TOWN OF BRISTOL, RHODE ISLAND

Technical Review Committee Agenda

Review of Master Plan phase for Major Land Development of the Comfort Inn and Suites to build an 80 room hotel. Property on south side of Gooding Avenue approximately 50 feet east of the intersection of Gooding Avenue and Broadcommon Road, near utility pole #218. Owner: D & M Boca Development, LLC Zoned: GB. Assessor's Plat 111 Lot 1.

RE: Major Land Development – Master Plan Phase Comfort Inn and Suites

Underground Detention System A

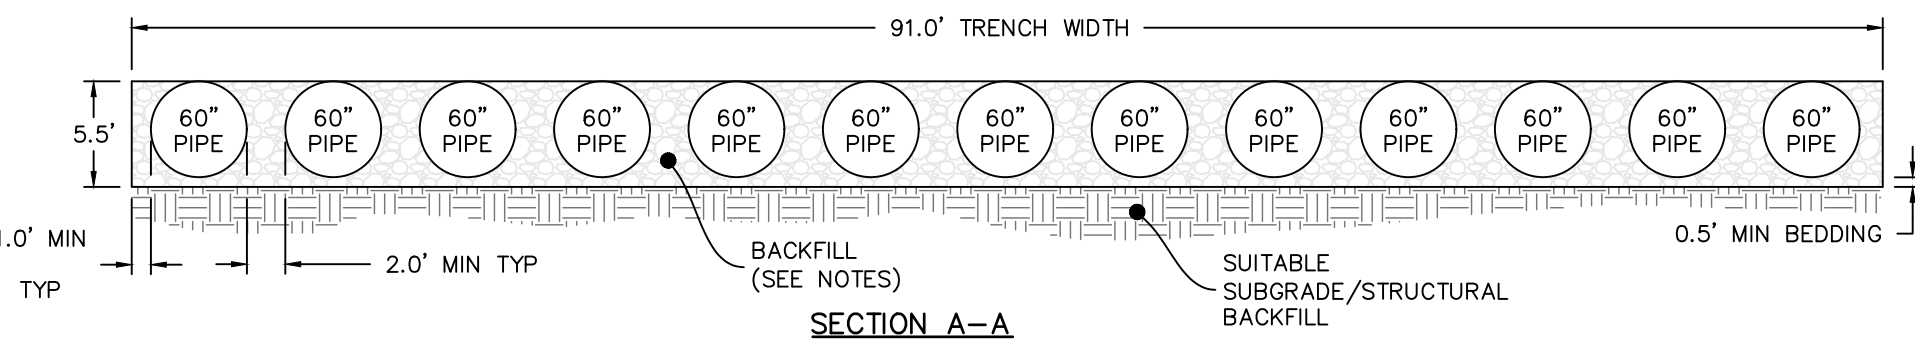
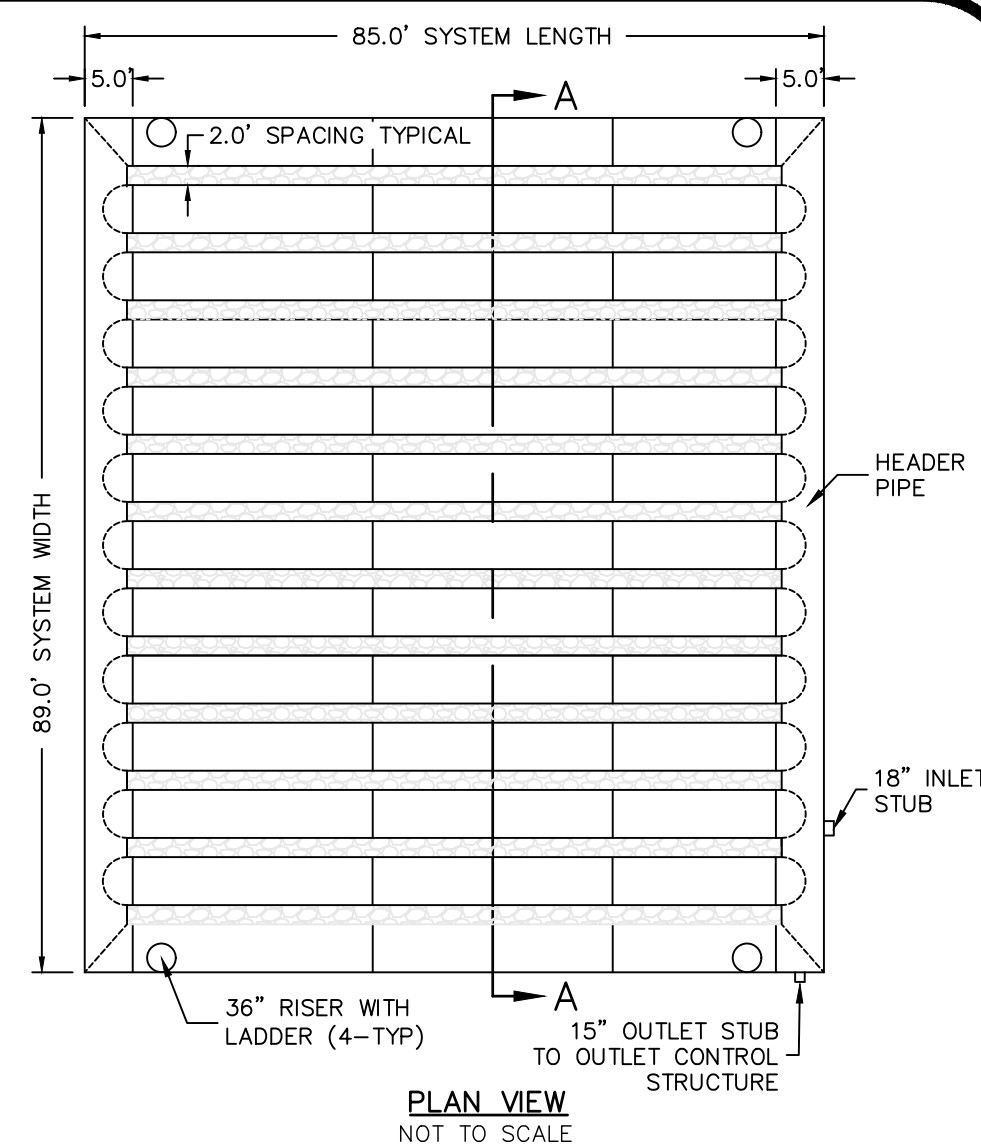
- 7. Underground System A & Details (Sheet 10 of 13)
 - a. Based on Slot Drain-20 rim elevation of 76.72' on the Grading Plan Sheet and assuming a typical curb reveal of 6", the parking lot finish grade is 76.22' at the bottom of curb. The top stone elevation over the UIS-A is listed at 76.50'. The 18" minimum cover is not provided over the system in this location.

WQ Bypass DMH-8 (6'Ø Manhole)

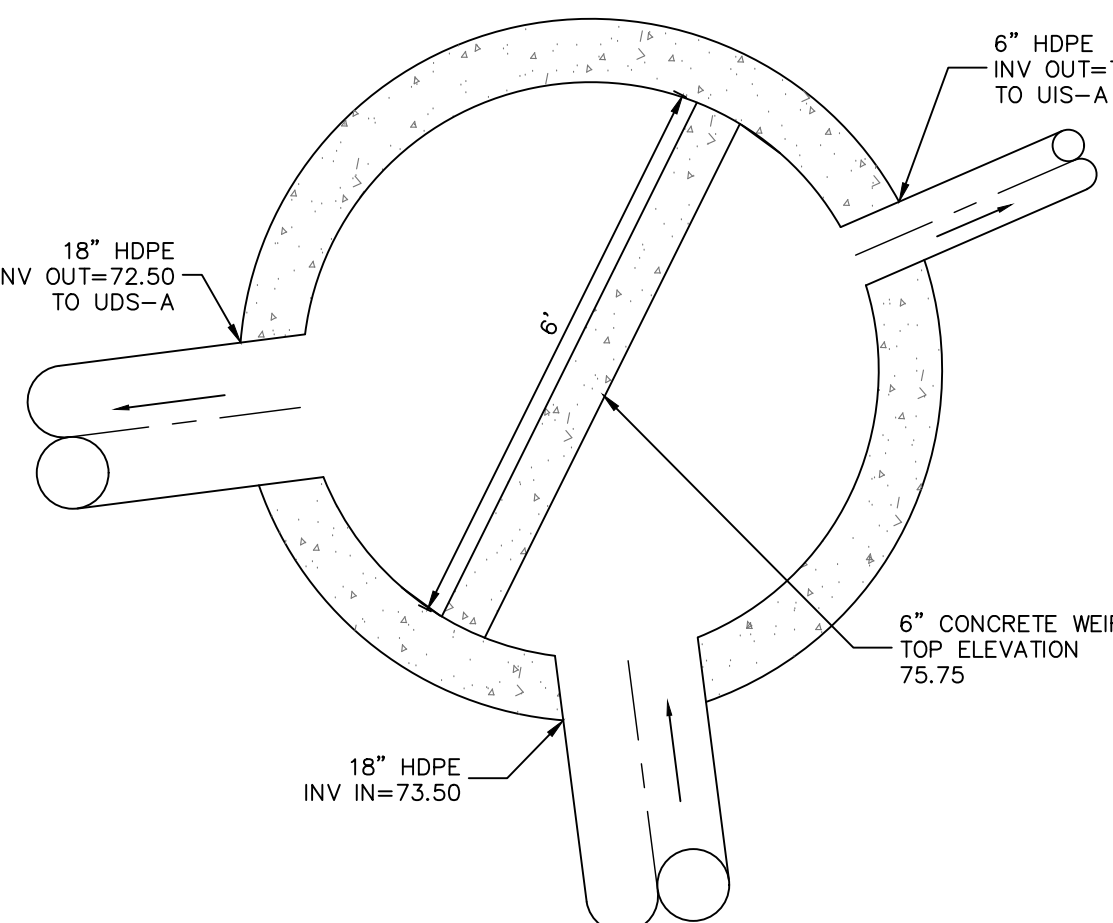
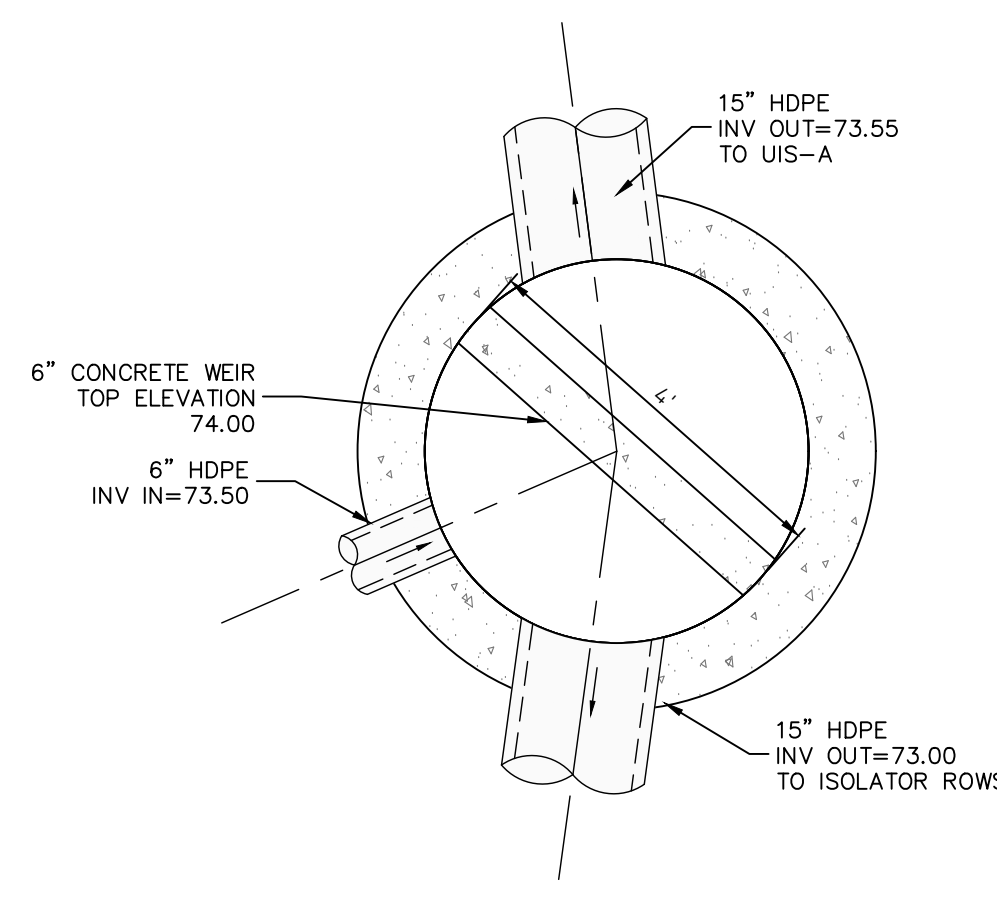
- 6. Drainage and Utilities Plan (Sheet 8 of 13)
 - a. Provide rim and invert information for DMH-8 (Bypass) and DMH-9 (Bypass).
 - b. Provide rim elevation of Slot Drain-20.

Underground System B, Sand Filter B & Details

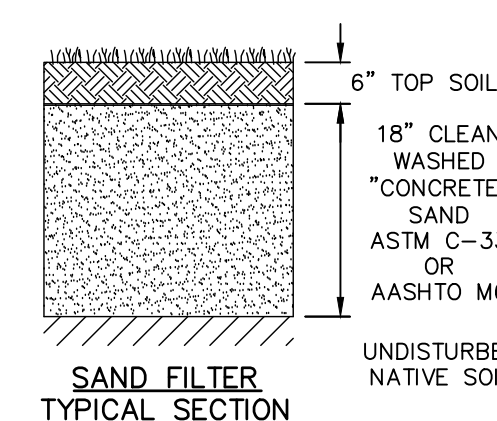
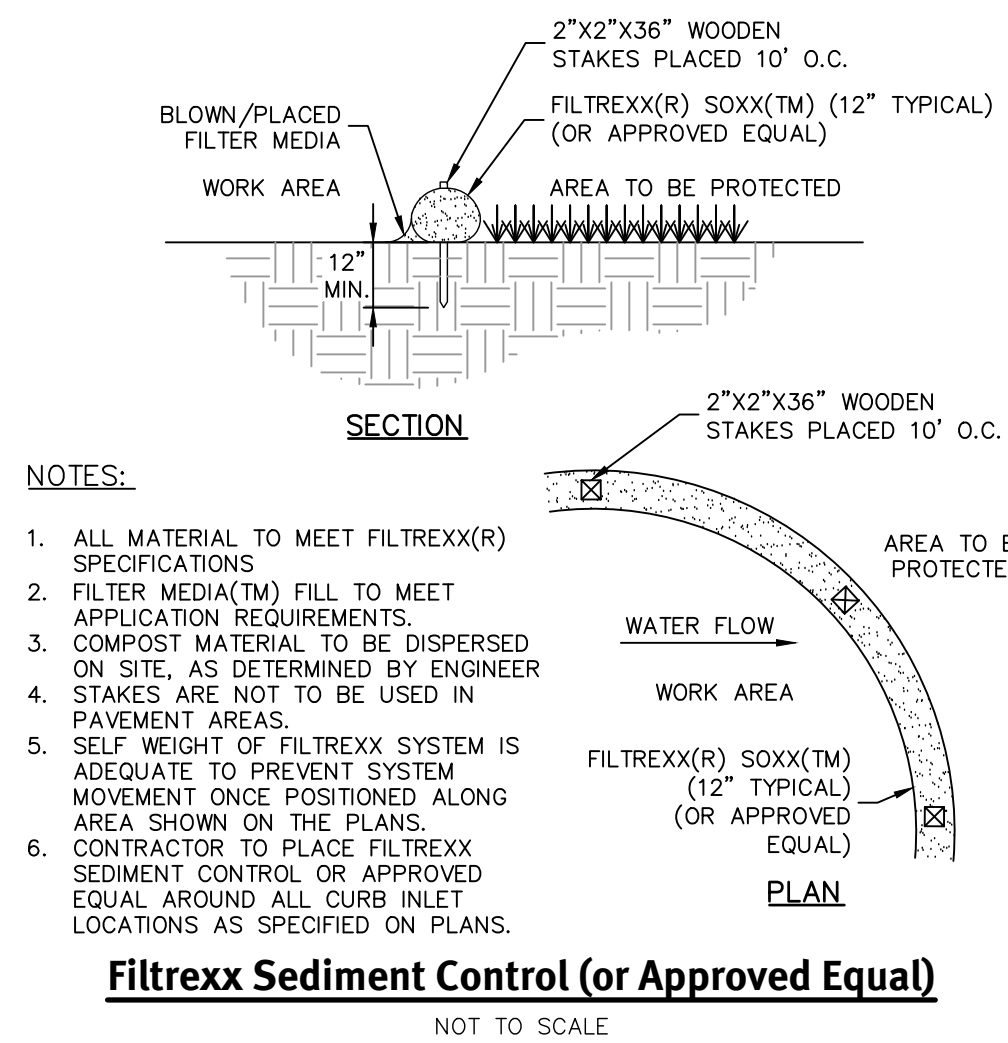
- 8. Underground System B, Sand Filter & Details (Sheet 11 of 13)
 - a. Separation of bottom of sand filter practice and groundwater table is 1-ft and not in compliance with the minimum separation requirement of 3 feet per 250-RICR-150-10-8.21.B.7.
